Deviations on the Flamanville EPR steam lines: the eight penetration welds will have to be repaired

Published on 20/06/2019 • 09:38 am

Information notice

Overview of the VVP lines (shown in red) EPR Flamanville 6 - copyright ASN

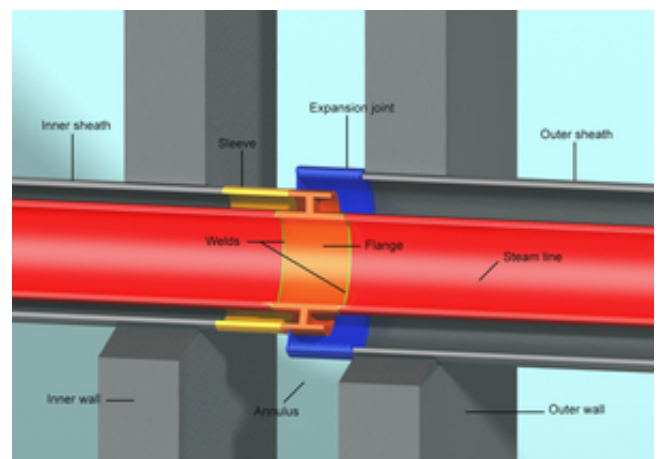
In a letter of 19 June 2019, ASN informed EDF that, in the light of the numerous deviations in the production of the Flamanville EPR penetration welds, they would have to be repaired.

In its opinion of 11 April 2019, the GP ESPN notably considered that the nature and particularly high number of deviations in the design and production of these welds were major obstacles to the application of a break preclusion approach.

Postponement of the repair operations until after reactor commissioning would pose a number of problems, notably with regard to demonstrating the safety of the reactor during the interim period. ASN therefore considers that repair of the welds concerned before commissioning of the reactor is the baseline solution.
